Docket Number:	22-SPPE-03
Project Title:	Martin Backup Generating Facility (MBGF)
TN #:	249350
Document Title:	Martin Properties Responses to CEC Data Request Set 1 - MBGF
Description:	N/A
Filer:	Scott Galati
Organization:	DayZenLLC
Submitter Role:	Applicant Representative
Submission Date:	3/17/2023 4:08:38 PM
Docketed Date:	3/17/2023

RESPONSE TO CEC STAFF DATA REQUEST SET 1 (1-47)

Martin Backup Generating Facility (22-SPPE-03)

Drawing of Generator Enclosure

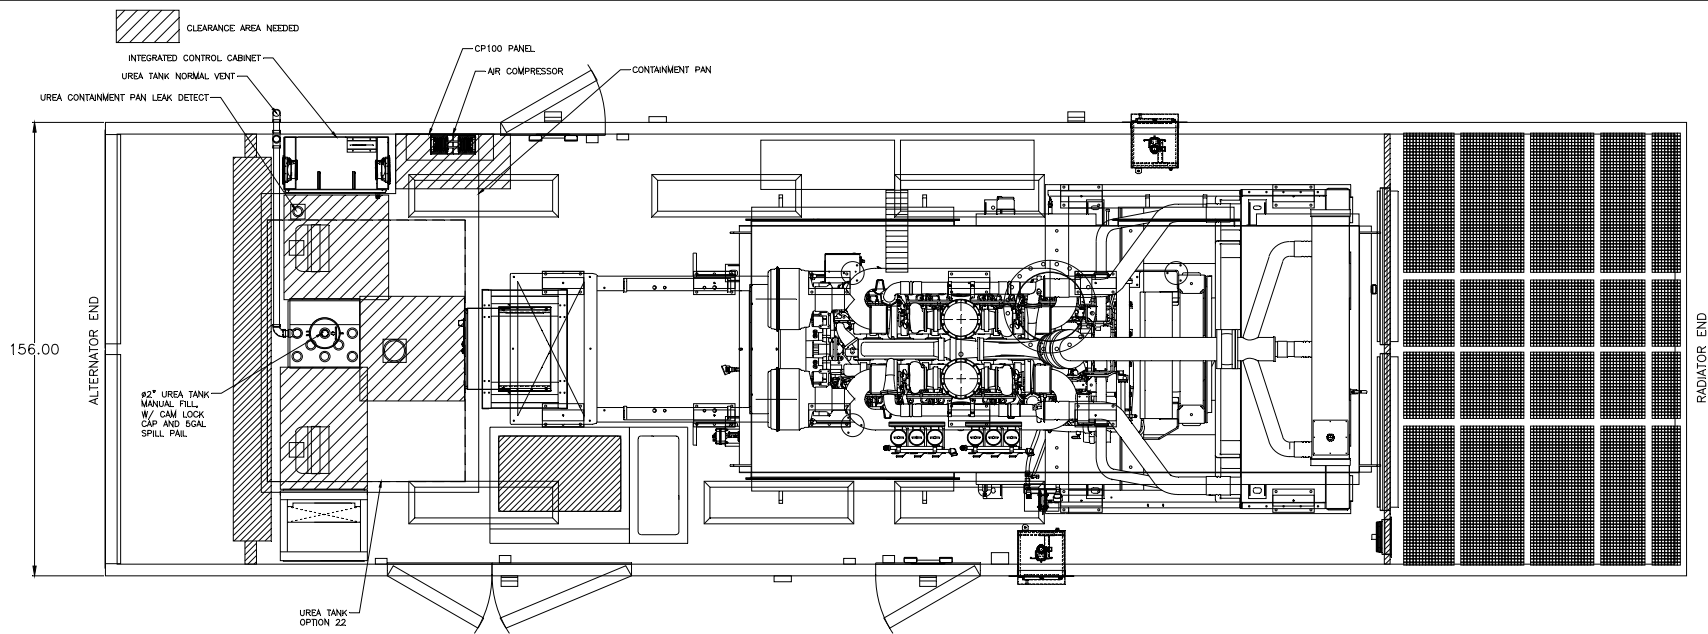
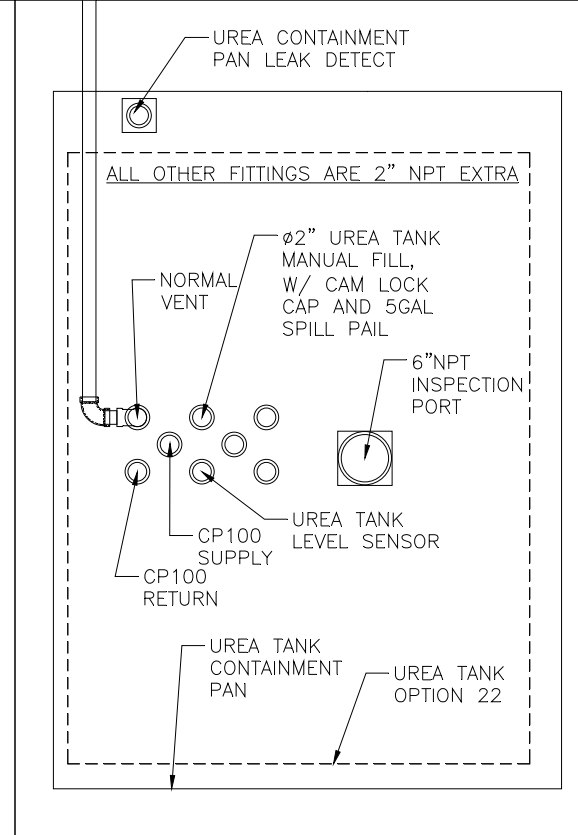
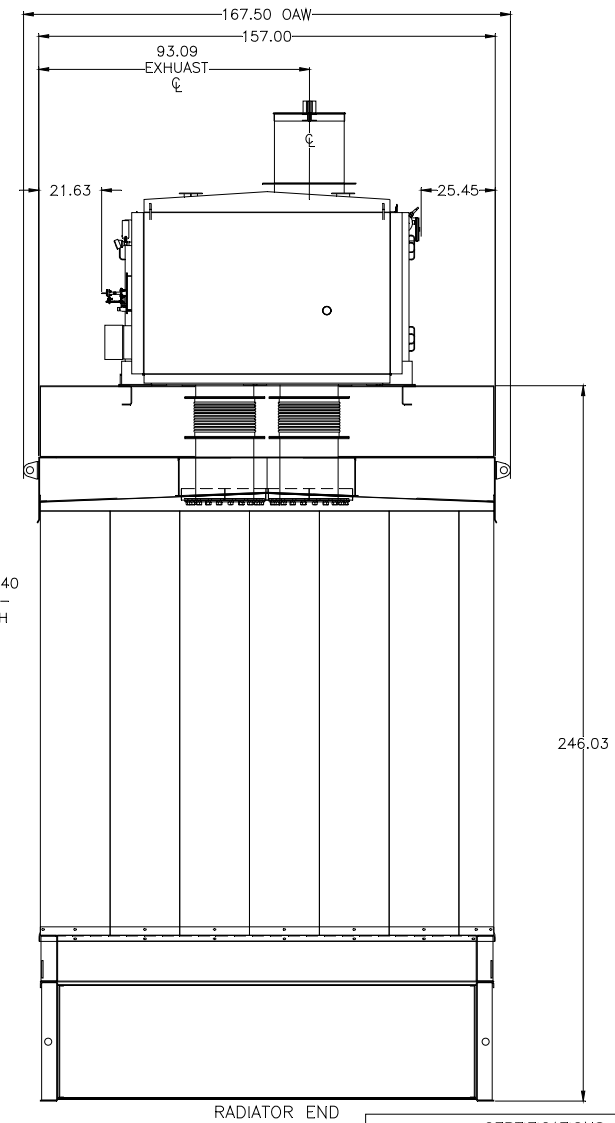
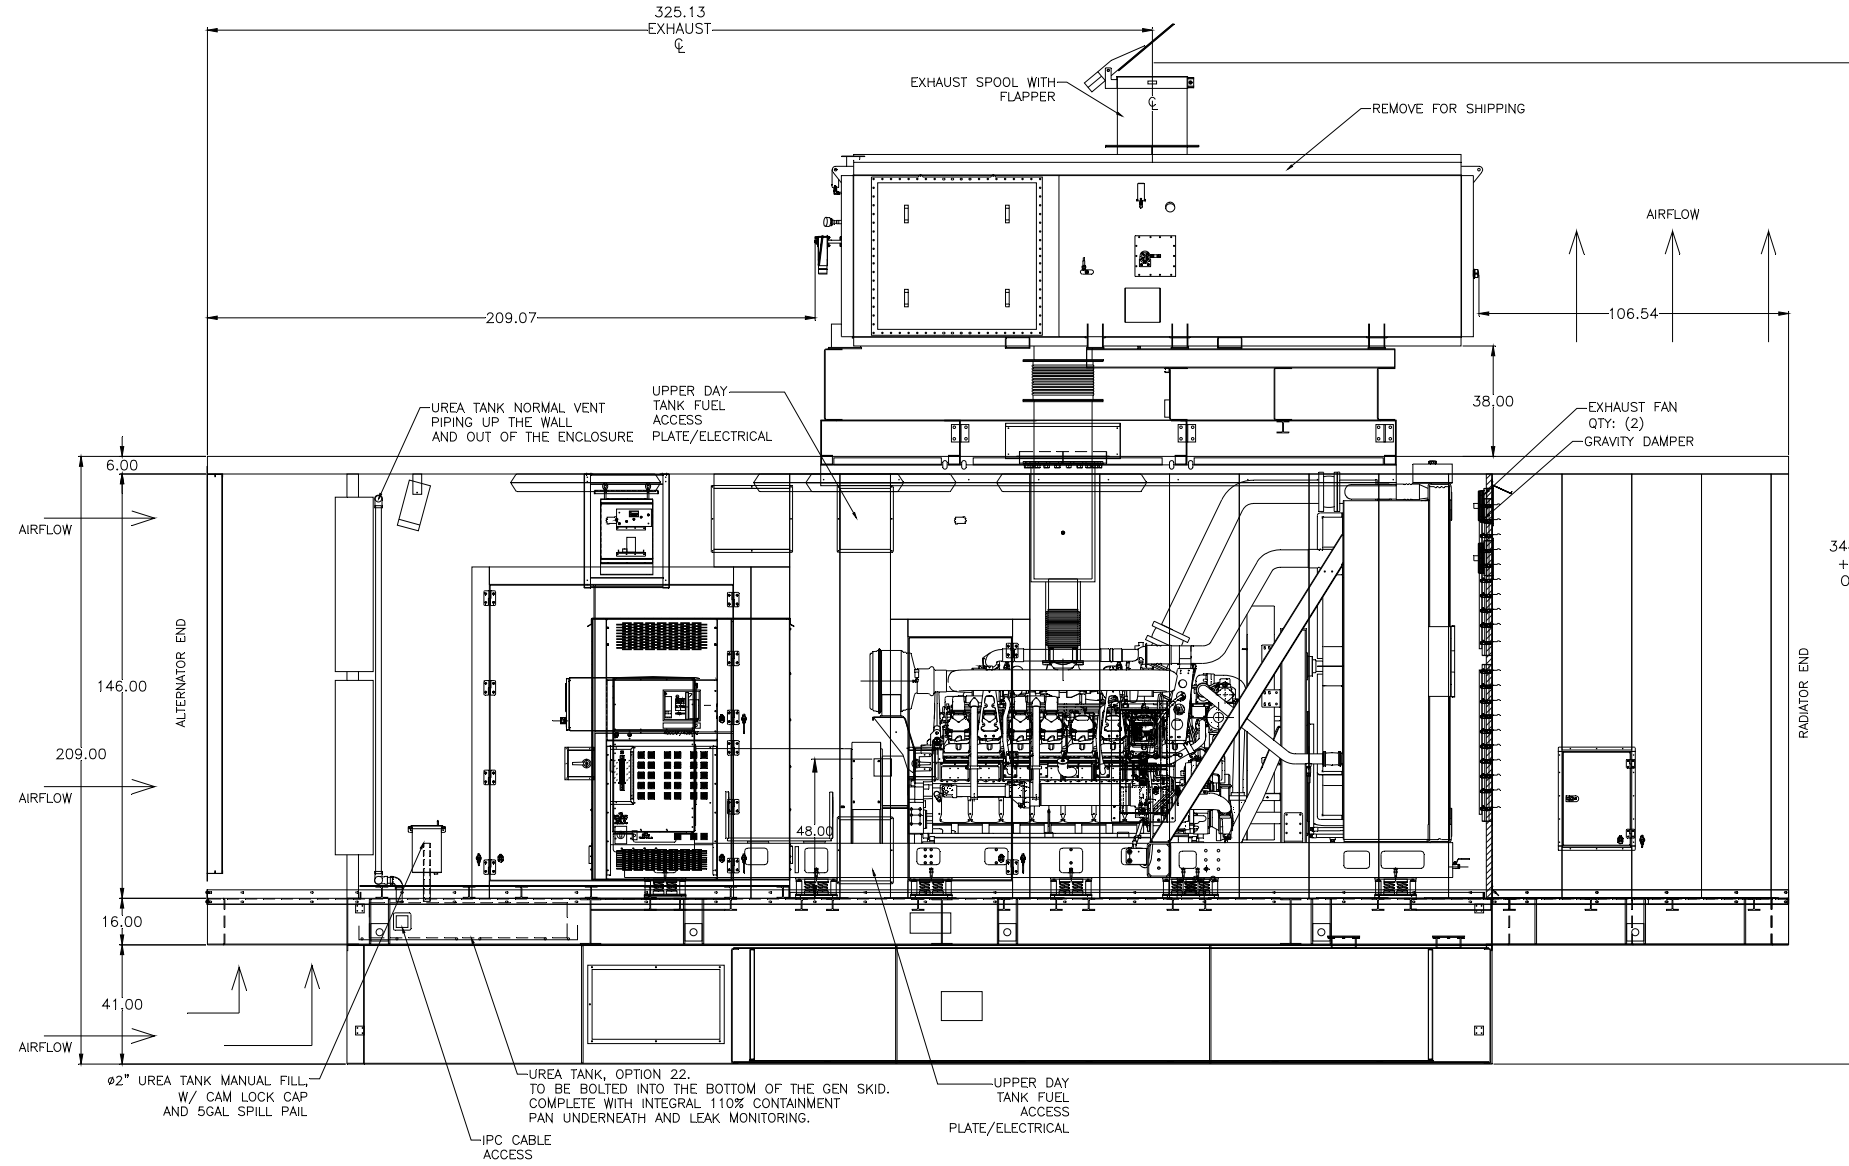
33. Please provide a schematic drawing showing the DEF containment within the generator enclosure.

The DEF will no longer be stored in 55-gallon drums but instead will be stored in a 250 gallon tank within the generator enclosure underlain by a 110 percent containment pan and leak detection monitoring. See drawings in Attachment HAZ DR-33.

Please see Attachment HAZ DR-33.
